World Forum for Harmonization of Vehicle Regulations

Consideration of draft amendments to existing

Proposal for the 01 Series of Amendments to UN Regulation No. 153 (Fuel system integrity and electric power train safety at rear-end collision)

Submitted by the Working Party on Passive Safety*

Model A
(See paragraph 4.4. of this Regulation)

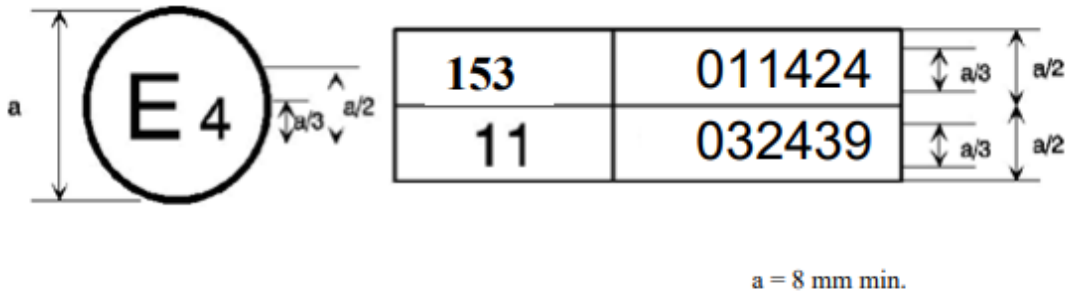
Annex 2, amend to read:

The above approval mark affixed to a vehicle shows that the vehicle type concerned has, with regard to the protection of the occupants in the event of a frontal collision, been approved in the Netherlands (E 4) pursuant to UN Regulation No. 153 under approval number 001424. The approval number indicates that the approval was granted in accordance with the requirements of UN Regulation No. 153 as amended by the 01 series of amendments.

Figure 3
Jointed Test Finger

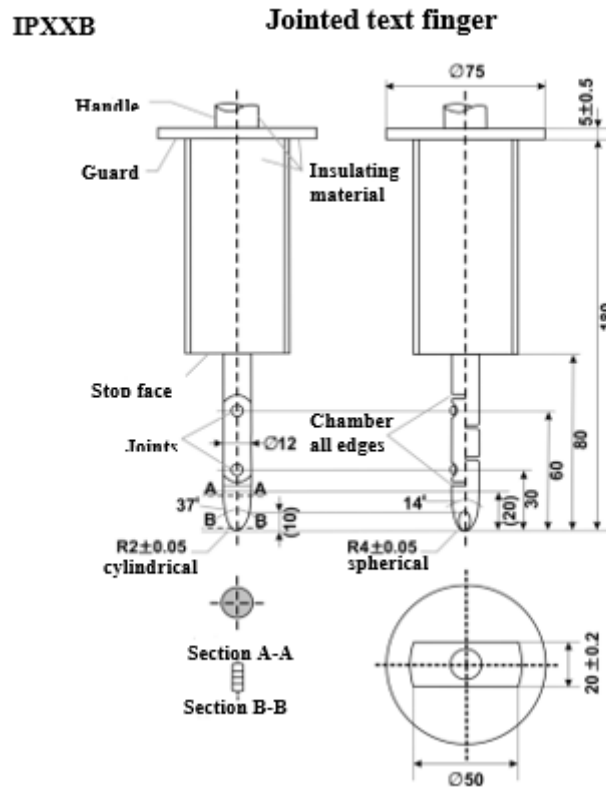
Annex 5, paragraphs 4. and 4.1., amend to read:

The jointed test finger described in Figure 3 shall be inserted into any gaps or openings of the physical protection with a test force of $10 \text{ N} \pm 10$ per cent for electrical safety assessment. If partial or full penetration into the physical protection by the jointed test finger occurs, the jointed test finger shall be placed in every position as specified below.

Starting from the straight position, both joints of the test finger shall be rotated progressively through an angle of up to 90 degree with respect to the axis of the adjoining section of the finger and shall be placed in every possible position.

Both joints shall permit movement in the same plane and the same direction through an angle of 90° with a 0 to $+10^\circ$ tolerance.

The requirements of paragraph 5.2.2.1.3. of this Regulation are met if the jointed test finger described in Figure 3, is unable to contact high voltage live parts.

Figure 4

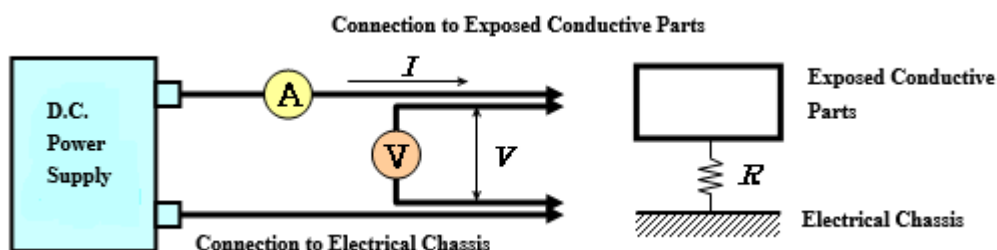
(b) Test method using DC power supply, voltmeter and ammeter.

The DC power supply, voltmeter and ammeter are connected to the measuring points (Typically, electrical chassis and electro conductive enclosure/electrical protection barrier).

The voltage of the DC power supply is adjusted so that the current flow becomes at least 0.2 A.

Example of the test method using DC power supply, voltmeter and ammeter is shown below.

The resistance R shall be less than 0.1 Ω .
